SERVICE LETTER

No. 874

Piper Aircraft Corporation

Low Fuel Warning Sensor Sealing

FIGURE 1

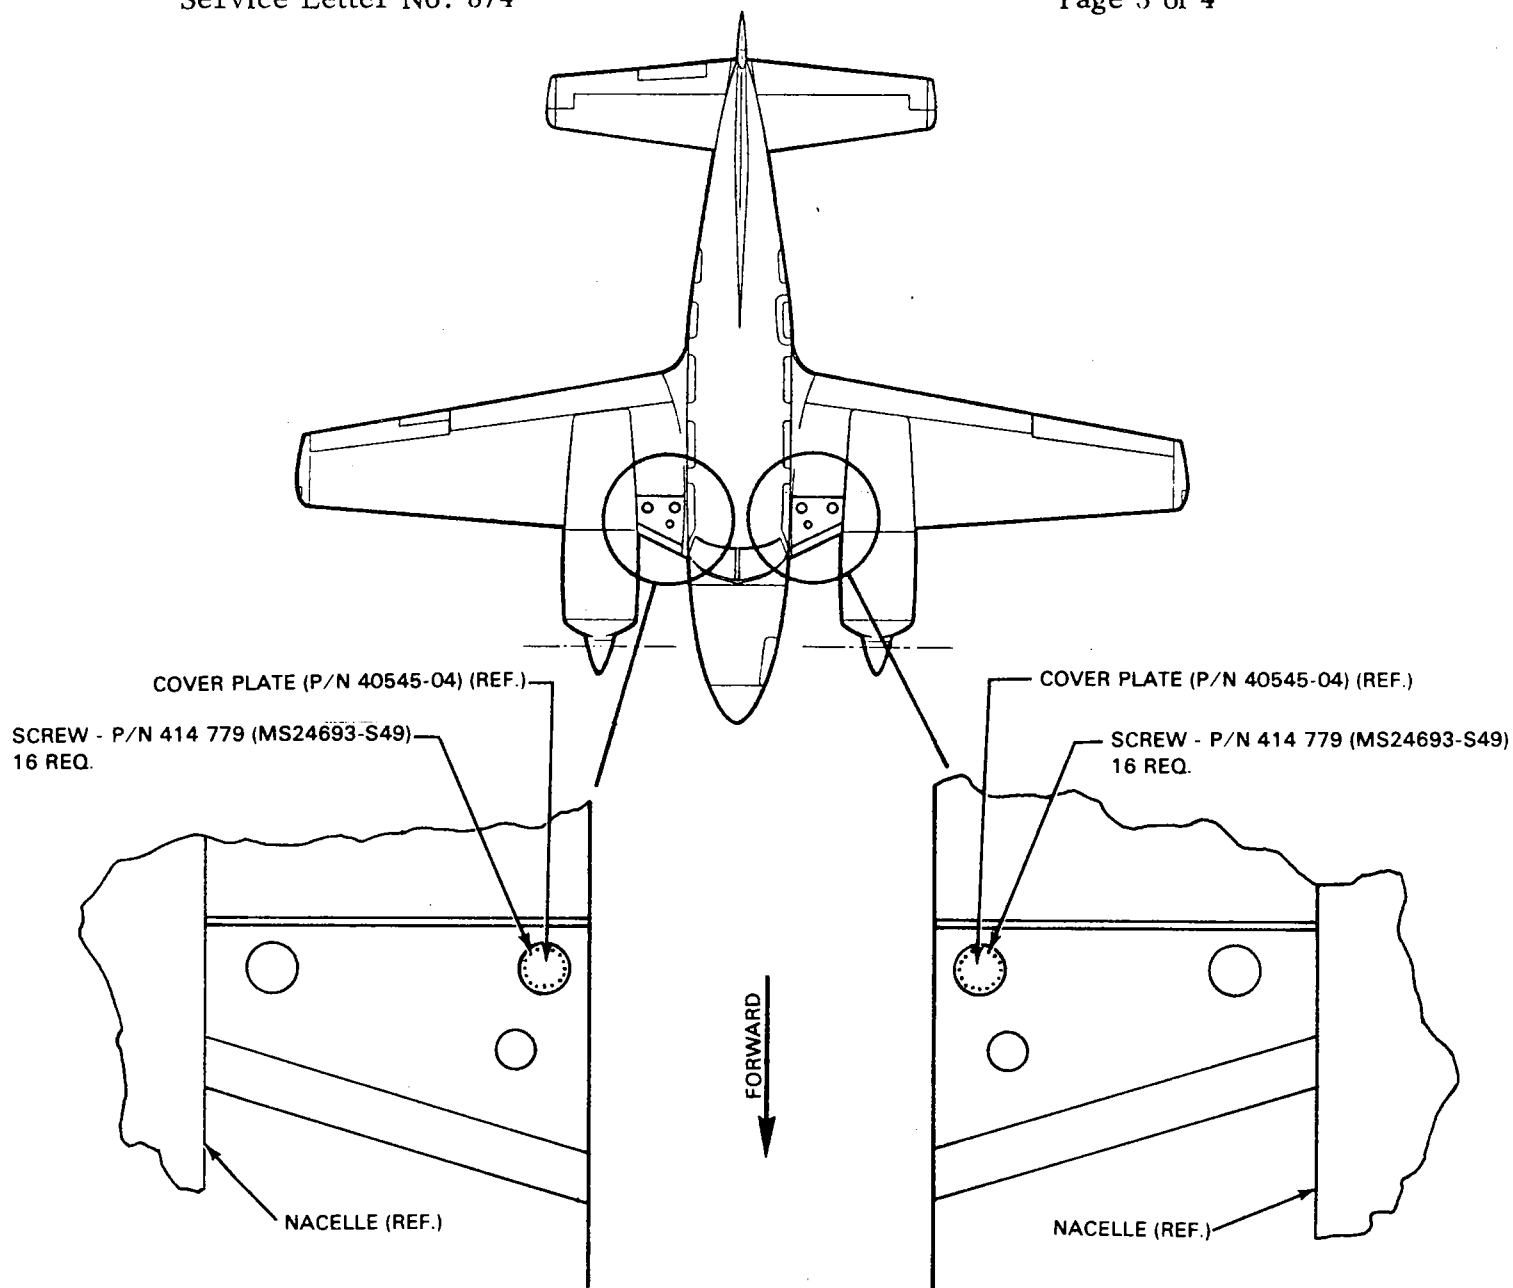
Field reports indicate that the possibility exists of fuel seepage from the area of the low fuel warning sensor attachment to the fuel cell. Such a condition, if left unattended, could allow fuel to streak the wing upper surface aft of the fuel warning sensor cover plate.

1. De-fuel the aircraft to obtain fuel level below low fuel warning sensor probe.
2. Remove MS24693-S49 screws and cover plates (Piper Part No. 40545-04) on left and right wings (See Figures 1 and 2).
3. Disconnect sender wire knife splice (See Figure 3.)
4. Remove AN4-4A hold-down bolts and AN936-A416 Washers, and lift sensor (Piper Part No. 54751-02) out of tank (Figure 3).
5. Remove cotter pin and castle nut. Disassemble sensor from fuel cell cover, and remove and discard gasket and AN960-816L washer (Figure 3).
6. Apply MIL-5-8802 B 1/2 sealant (or equivalent) between plate and mounting surface of sensor.
7. Assemble plate on sensor per details shown in Figure 3. It is acceptable to use a combination of light and regular washers to obtain alignment between the cotter pin hole and castellation. Do not exceed 45 in-lbs of torque.
